FW: White House Signage

To: Intern, HPC <hintern@milwaukee.gov> Please add to the White House COA file.

Subject: RE: White House Signage

Example of raised letters

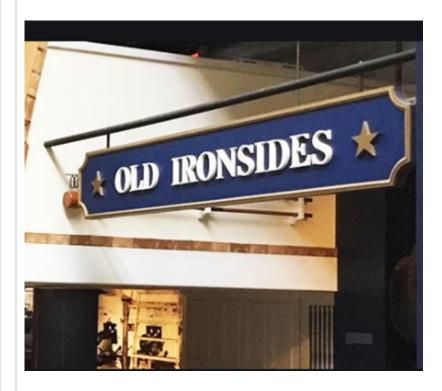
You current sign is Type A due to size and projecting letters. To retain that status, new letters would have be raised not painted on. They could be made of wood. If you want to have raised letters, please tell me that. As staff we would recommend raised letters to be consistent with our requirements on other historic properties

To have just painted letters, the commission would have to approve and then you'd have to get a variance which has a fee attached since you are changing a type A sign to a Type B sign. Do you want to stay with painted letters?

What do you think of the font style we mailed you? It is close to the font style of the neon. Your proposed font is storybook in style. Do you want the font type you sent in or would you prefer the font style we sent you?

Comment: Have you considered restoring the portion of the neon sign that reads "White House"? You would remove the Kneisler name and substitute your own, the words Bay View or some form of ornamentation. Also, the sign face will show damage/holes when you remove the neon and its electrical connections. Will it still be usable? Have you considered what to do about that?

Thank you for reaching out, I have discussed with my husband and we are going to go ahead with the raised wood lettering as recommended. We would prefer to stay with the style displayed on our mock up from our artist. As for the holes from the neons between taken out, any holes remaining after the raised wood lettering gets installed would be caulked sanded and painted to provide a smooth surface finish. Please let me know if you have any questions.
